Project: P2023-050
 Application Numbers: OCP23-004 R23-014

Subject: Development Application – 32909 Rosetta Avenue – OCP and Rezoning Amendments

DATE: March 3, 2025
BYLAW / PERMIT #: 6321-2024-5670(52) (OCP)
 6322-2024-5949(173) (Zoning)
PROPERTY ADDRESS: 32909 Rosetta Avenue
LOCATION: Cedar Valley
CURRENT ZONING: Suburban 20 Zone (S20)
PROPOSED ZONING: Multi-unit Townhouse One Zone (MT1) and Institutional Parks, Recreation and Civic Zone (IPRC)
CURRENT OCP: Attached Multi-unit Residential, Urban Residential, and Protected Natural Assets
PROPOSED OCP: Attached Multi-unit Residential and Protected Natural Assets
PROPOSAL: To amend the OCP and rezone the property to facilitate a 15-unit townhouse development.

ATTACHMENT A
**ENGINEERING AND PUBLIC WORKS DEPARTMENT
REZONING AND DEVELOPMENT PERMIT COMMENTS**

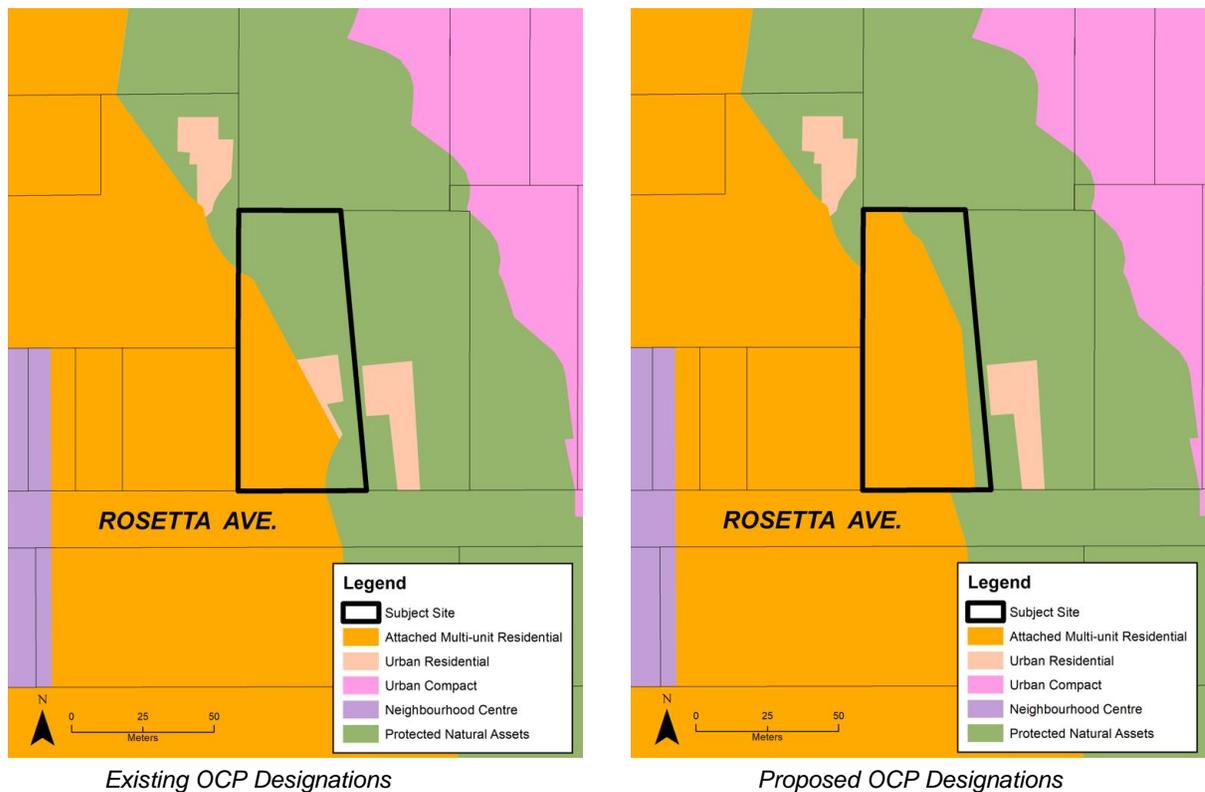
As the developer is unable to dedicate further land on the site to the City, they are offering a cash contribution of \$108,000. Their compensation letter is included as **Attachment C**.

The land that remains designated as PNA will be dedicated to the City and will be rezoned to the IPRC Zone to strengthen its environmental protection. The developer has also offered to construct a walking trail through the PNA area as per the Cedar Valley Engineering Plan (CVEP).

SHEET TITLE:
SITE PLAN ZONING ANALYSIS REVIEW

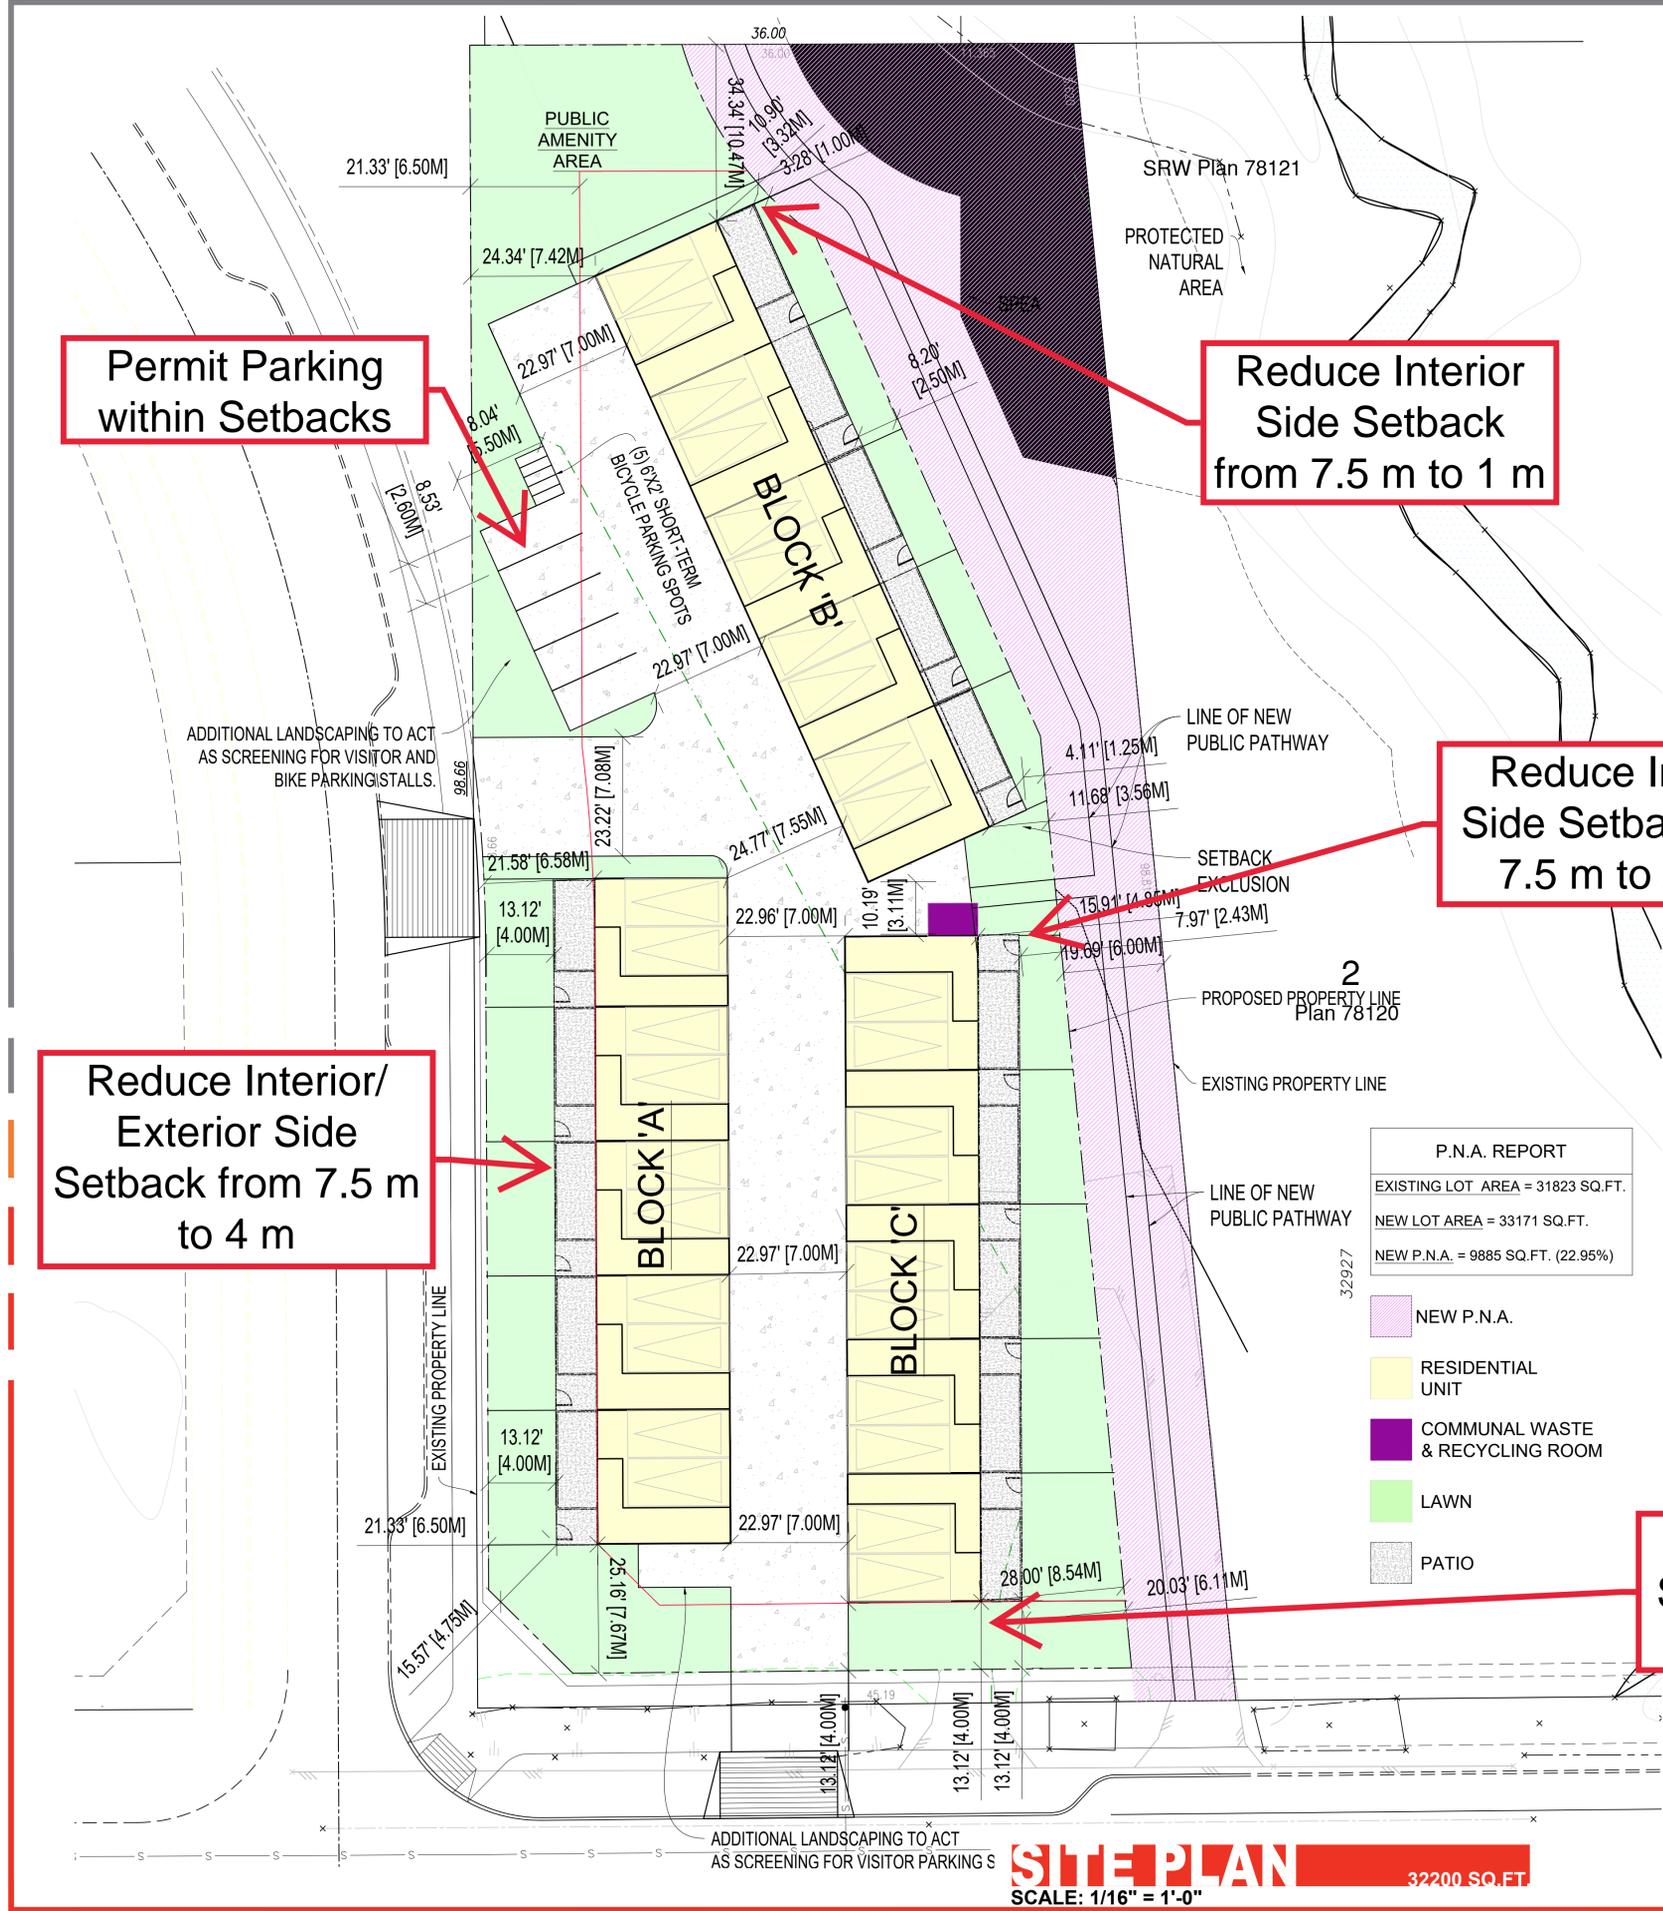
- *Reduce the front lot setback from the southern property line from 6 m (19.7 ft) to 4 m (13.1 ft) for Block 'C' (Zoning Bylaw Section 704.D.1)*

- *Reduce the interior side lot setback from the east property line from 7.5 m (24.6 ft) up to 1 m (3.3 ft) for Blocks 'B' and 'C' (Zoning Bylaw Section 704.D.1)*

- *Reduce the interior side lot setback from the west property line from 7.5 m (24.6 ft) to 4 m (13.1 ft) for Block 'A' (Zoning Bylaw Section 704.D.1)*

- *Permit parking stalls within setbacks (Zoning Bylaw Section 704.I.3)*

Following a review of the proposed variances, the Engineering Department recommends that the application be reconsidered due to potential negative impacts on Environmentally Sensitive Areas (ESAs) and Protected Natural Assets (PNAs).

This request comes due to the spatial limitations of the site presented by the PNA areas. Additionally, a front lot setback reduction to 4 m (13.1 ft) is common when a garage is located at the back of the townhouse unit, away from the street. In this case, the garages are located on the side of the 'Block C' townhouse units but are still facing away from the adjacent street.

This request is a result of the site's proximity to the PNA areas, which borders the site's eastern side and constrains the amount of developable area on the lot. There is no risk of overshadowing, privacy concerns, or conflicts with neighbours associated with this request due to it bordering the PNA area.

The west property line will be an exterior lot line once the future road to the west of the property, Pearson Way, is constructed. Typically, a 4 m (13.1 ft) setback is permitted for front lot lines when garages are located at the back of the building. As the units in Block 'A' will be fronting a road in the future, the applicant is requesting this be treated like a front lot line and the 4 m (13.1 ft) setback be permitted. The garages are located at the back of the Block 'A' townhouse units, away from the street. Furthermore, it is only the townhome's balconies that extend to 4 m (13.1 ft). The building's face is setback at 6.6 m (21.6 ft).

The developer has located visitor parking stalls within the property's setbacks in order to maximize site efficiency and functionality while still providing the required number of parking stalls. The developer has agreed to place enhanced landscaping around these parking stalls, thereby screening and separating the parked vehicles from the sidewalk and street.
